Service Bulletin

R1901

Engine Software and Data Plate Update

4/18/2019

**MX-11****MX-13**

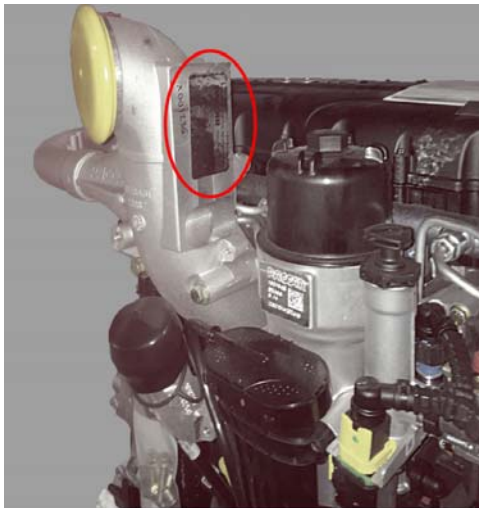
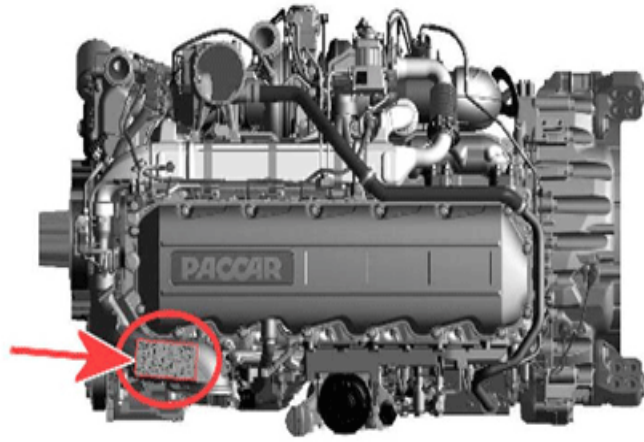
Some vehicles, equipped with pre-production Engine Model Year 2019 PACCAR MX-13 or MX-11 engines, were manufactured with temporary emissions exemptions that will soon expire. These expiring emissions exemptions must be updated to production levels by updating the engine software and adding a new emissions label.

1. See bulletin [E134](#) for instruction to update the software.
2. See the [Replacement Label Procedure](#) under Vehicle Support Center Bulletins to order replacement labels.
3. Include with your claim a clear and in-focus photo of the installed new label with your claim.
